APPLICATION NO.	FILING DATE	FIRST NAMED INVENTOR	ATTORNEY DOCKET NO.	CONFIRMATION NO.
09/590,586	06/08/2000	William W. Holmes IV	U6220/53569/NWJ-gasket	1012

Office Action Summary

DETAILED ACTION

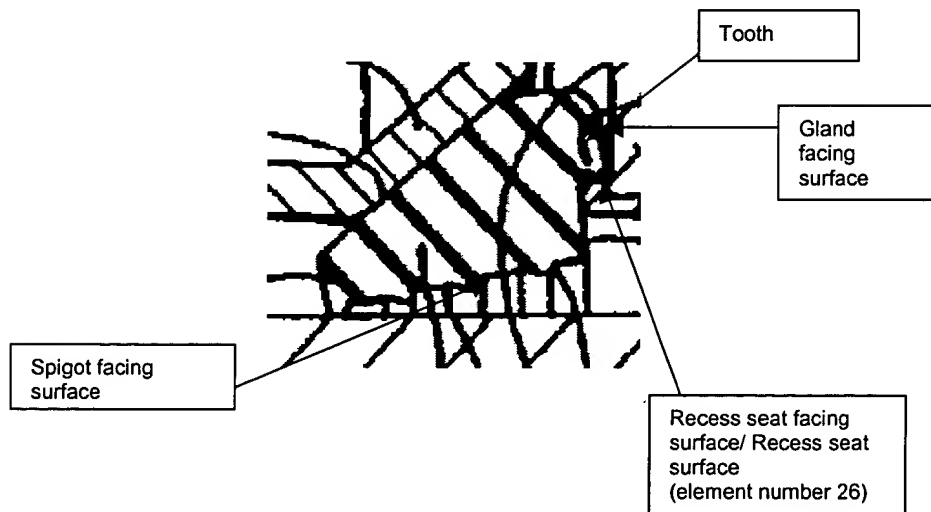
Re: claims 2, 3, 4, 5, 11, and 16. Harper shows in figure 1 a pipe joint comprising a male first pipe portion 4, a female second pipe portion 2, a compression gland 6 having a lip 8 located at an inner diameter of the gland disposed at least

partially within (the extrapolated boundaries of) the second pipe portion to the same extent as Applicant's, and a restraining gasket shown in the area of element number 10 within the second pipe portion and between the first pipe portion and the second pipe portion, the gasket further comprising: a compressible body having a spigot-facing surface, a recess seat-facing surface and a gland-facing surface, but does not include the limitation of a locking member.

Miller teaches in figure 16 the use of a locking member 72 (being of the form illustrated in figure 1 as disclosed in the left column of pg, 4 lines 22-23), the locking member 72 having a tooth 72b and a back portion or upper surface at least partially embedded within a compressible body 61 wherein at least a portion of the tooth is positioned to engage a first pipe portion 10 wherein the locking member is adapted to pivot (as a result of the conical end portions 60 of element 13c in which the front portions of the locking member are wedged and as a result of the rear portions 73 being supported) in response to a force tending to separate the first pipe portion from the second pipe portion, and wherein the locking member is adapted to resist movement between the first pipe portion and the compression gland in the event of such force.

It would have been obvious to one of ordinary skill in the art at the time the invention was made to have modified the gasket of Harper to have included a locking member, as taught by Miller, in order to provide a means of more securely connecting the first and second pipe portions.

portions, the gasket comprising a compressible body adapted to encircle a spigot end of a first pipe length 4 and adapted to fit within a bell end of a second pipe length 2, the gasket having a spigot facing surface, and a recess seat surface as labeled above, shows a gland meeting area shown in the area of the gland facing surface, a recess seat meeting area shown in the area of the recess seat surface, and the recess seat meeting area disposed in proximity to the recess seat surface, but does not show the limitation of the compressible body having embedded therein a locking member having a toothed edge shown in the area of the spigot facing surface, the toothed edge disposed in proximity to the gland facing surface.

Re: claims 14 and 15. Harper, as modified, shows in figure 1 of Harper the gland facing surface or the recess-seat meeting area comprising a tooth as shown in the labeled portion of figure 1 of Harper.
